Review of England & Wales Approved Document J 2002

Submission paper: OFTEC ADJ02 – J6 Domestic Risk Assessment

Requirement J6 and Approved Document Guidance relating to Oil Storage tanks.

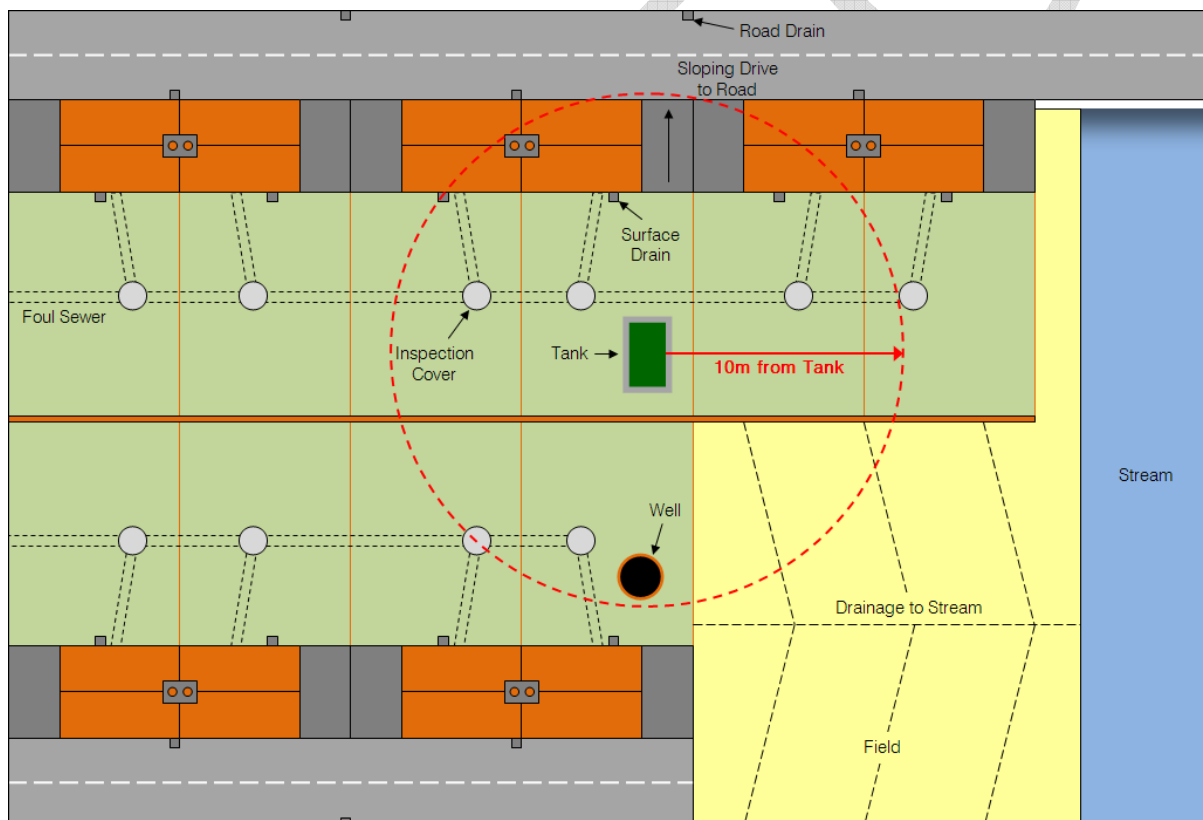
Despite such additional industry guidance as utilised by OFTEC Registered Technicians the 10m & 50m locality rules are in reality impractical to apply. For example an individual attending a site would in normal circumstances only have authority to inspect the property on which the oil tank is proposed to be installed (as would an LABC Officer when policing same). If for example a street of houses have 8m wide plots then the assessor would not have legal access to the adjacent properties under the 10m rule, let alone the total 14 properties (7 up and 7 down the street) and for example the additional 15 properties which may lie behind the proposed site to ascertain any potential risk under the 50m rule. How does one identify for example where perforated land drainage pipes (please see 5.9 above and diagram below) are installed either at the site in question or adjacent land or properties?
